# Access Compliance Report

## Public Rights-of-Way

### (Pedestrian Signals)

Intersection ID: N/A	Main Street:	Cross Street: N/A	Location: N/A
ADA ID: C0D3A5192251	Signal Type: One Push Button-APS	Overall Compliance: No	Severity Score: BTN 1: N/A BTN 2: N/A No BTN: N/A
Codes/Mitigation Info/Possible Solution		Field Measurements/Component Compliance

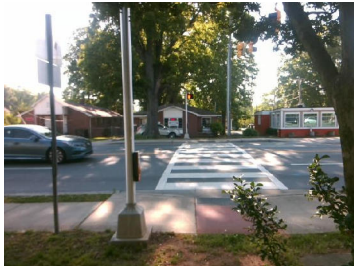
Compliance	Description	Data	Compliance	Description	Data
	Button Count	Button1	N/A	Distant to Additional Button (in)	N/A
	Additional Button Present?	No		Additional Button ID	N/A
N/A	Signal Buttons Required?	N/A	N/A	Additional Ped Posts Required	N/A
	How Many Ped Street Xings?	1		Located In An Island/Median?	No
N/A	B 1 Sign Present?	Yes	N/A	B 2 Sign Present?	N/A
Yes	B 1 Sign Purpose?	Yes	N/A	B 2 Sign Purpose?	N/A
Yes	B 1 Sign Lettering & Contrast?	Yes	N/A	B 2 Sign Lettering & Contrast?	N/A
Yes	B 1 Parallel To XWalk?	Yes	N/A	B 2 Parallel To XWalk?	N/A
Yes	B 1 PAR to Button?	Yes	N/A	B 2 PAR to Button?	N/A
Yes	B 1 PAR to XWalk?	Yes	N/A	B 2 PAR to XWalk?	N/A
Yes	B 1 Clear Floor Space?	Yes	N/A	B 2 Clear Floor Space?	N/A
N/A	B 1 FWD Approach?	No	N/A	B 2 FWD Approach?	N/A
N/A	B 1 FWD Approach Constrained?	No	N/A	B 2 FWD Approach Constrained?	N/A
N/A	B 1 FWD Approach Reach (in)	N/A	N/A	B 2 FWD Approach Reach (in)	N/A

N/A	B 1 FWD Approach Width (in)	N/A	N/A	B 2 FWD Approach Width (in)	N/A
N/A	B 1 FWD Approach Obstruction?	Yes	N/A	B 2 FWD Approach Obstruction?	N/A
N/A	B 1 FWD Approach Obstruction Dist (in)	6.0	N/A	B 2 FWD Approach ObstructionDist (in)	N/A
N/A	B 1 PARA Approach?	Yes	N/A	B 2 PARA Approach?	N/A
N/A	B 1 PARA Approach Constrained?	No	N/A	B 2 PARA Approach Constrained?	N/A
Yes	B 1 PARA Approach Reach (in)	8.0	N/A	B 2 PARA Approach Reach (in)	N/A
N/A	B 1 PARA Approach Width (in)	60.0	N/A	B 2 PARA Approach Width (in)	N/A
N/A	B 1 PARA Approach Obstruction?	Yes	N/A	B 2 PARA Approach Obstruction?	N/A
N/A	B 1 PARA Approach Obstruction Dist (in)	6.0	N/A	B 2 PARA Approach ObstructionDist (in)	N/A
No	B 1 Clear Floor Space Slope (%)	2.6	N/A	B 2 Clear Floor Space Slope (%)	N/A
No	B 1 Clear Floor Space XSlope (%)	3.5	N/A	B 2 Clear Floor Space XSlope (%)	N/A
N/A	B 1 PAR Slope (%)	1.8	N/A	B 2 PAR Slope (%)	N/A
Yes	B 1 Height (in)	32.0	N/A	B 2 Height (in)	N/A

Yes	B 1 Clear Xing Direction?	ClearlyMarked	N/A	B 2 Clear Xing Direction?	N/A
	B 1 Crossing Direction	To E		B 2 Crossing Direction	N/A
Yes	B 1 DistanceTo XWalk (in)	0.0	N/A	B 2 DistanceTo XWalk (in)	N/A
No	B 1 DistanceTo Curb (in)	85.0	N/A	B 2 DistanceTo Curb (in)	N/A
Yes	B 1 Diameter (in)	2.0	N/A	B 2 Diameter (in)	N/A

Possible Solutions: Replace Signal Push Button With APS Button on New Post. Remove & Relocate Sign.

PROW/ADA: TMUTCD 4e.08, R404.2, R404.3, R209.1, MUTCD 4e.10
